Staff Summary Report

Development Review Commission Date: 11/18/08

SUBJECT: Hold a public meeting for a Development Plan Review for CHASE BANK located at 830 South Mill Avenue.

DPR08219 – Development Plan Review including site plan, building elevations, and landscape plan.

sheet title
BUILDING SECTIONS
 DATE PLOTTED: 08/26/2024
 PLOTTED BY: JEFFREY

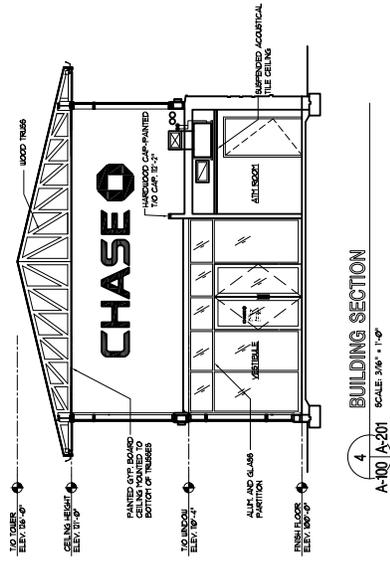
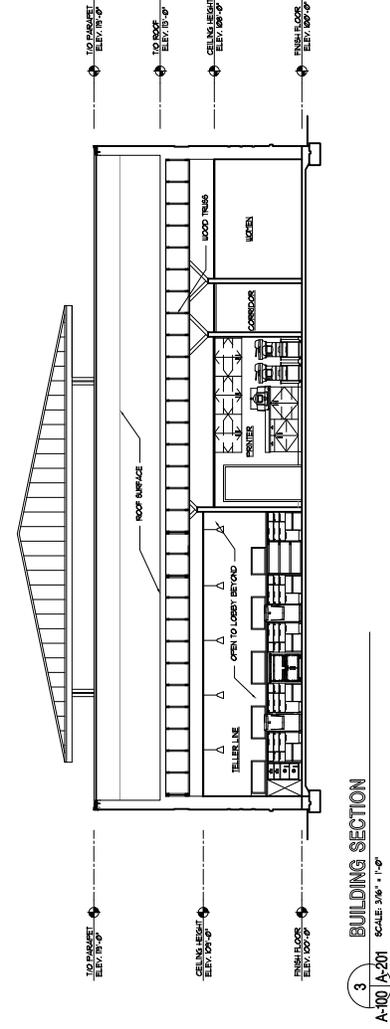
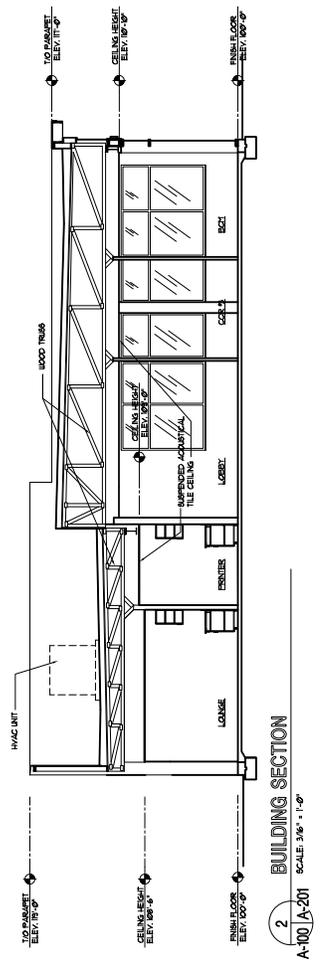
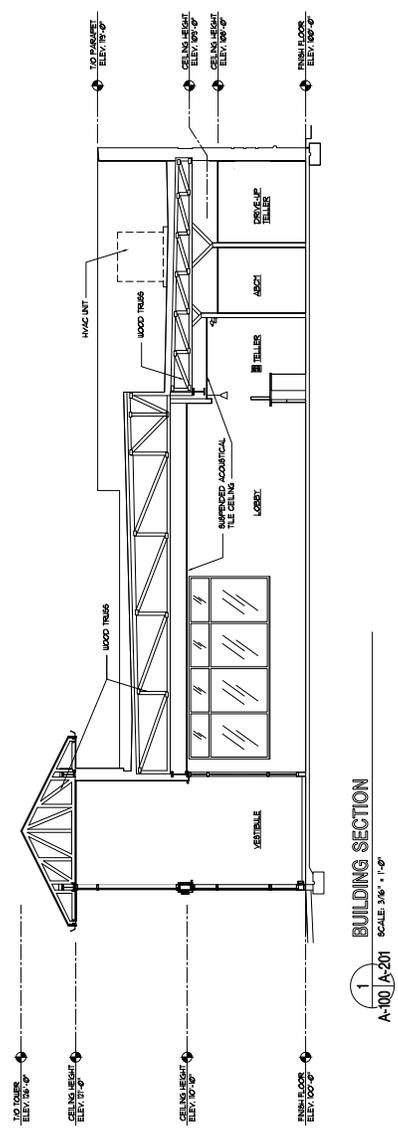
13. Conceal roof access within the building as indicated. Top of roof ladder is not allowed to protrude above roof parapet. Conceal all roof mount mechanical and other equipment behind parapets or other building features on all four sides.

- 15. Conceal roof drainage system including primary and overflow drains within the building. Minimize visible, external features and position these where exposed to enhance the architectural design. Position roof drain primary and overflow outlets to minimize storm water flow on walkways.
- 16. Incorporate lighting, address signs, and incidental equipment attachments (alarm klaxons, security cameras, etc.) where exposed to enhance the architectural design. Exposed conduit, piping, or related materials is not permitted.
